OXY USA WTP LP  
Myers Langlie Mattix Unit #202  
API No. 30-25-11035

### SUNDRY NOTICE SPECIAL STIPULATIONS

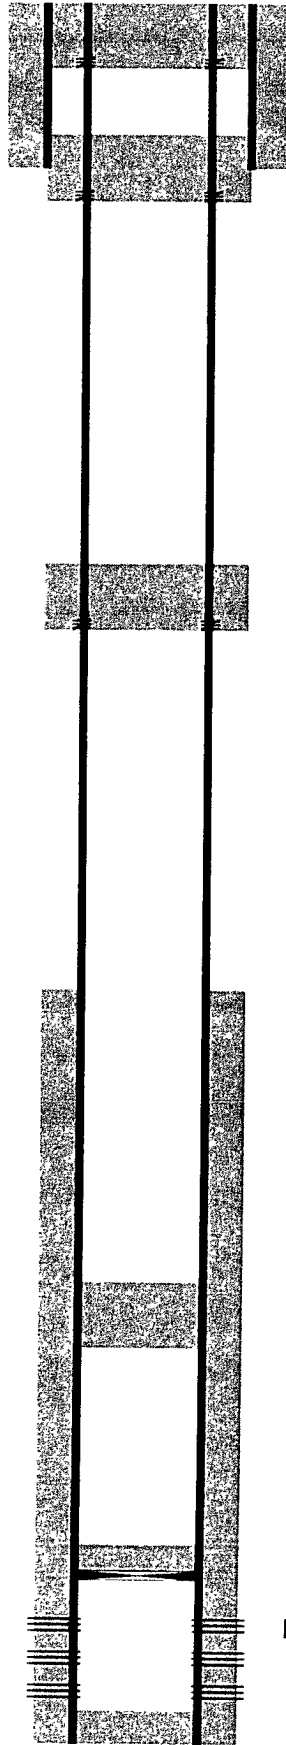
1. Approval is granted to plug this well with the following modifications:
2. The perf and squeeze proposed for 1325' should be moved to 1375' for the top of the salt, leaving at least 25 sacks inside of the casing.
3. The plugs @ 2850' and 1375' must be tagged.

**\*\*\*All plugs below the surface plug must be at least 100' and 25 sacks of cement plus an additional 10% for each 1000 feet of depth.**

**Plugging procedures must conform to 43 CFR 3162.6.d and Onshore Order No. 2.III.G or NMOCD orders if they are more stringent.**
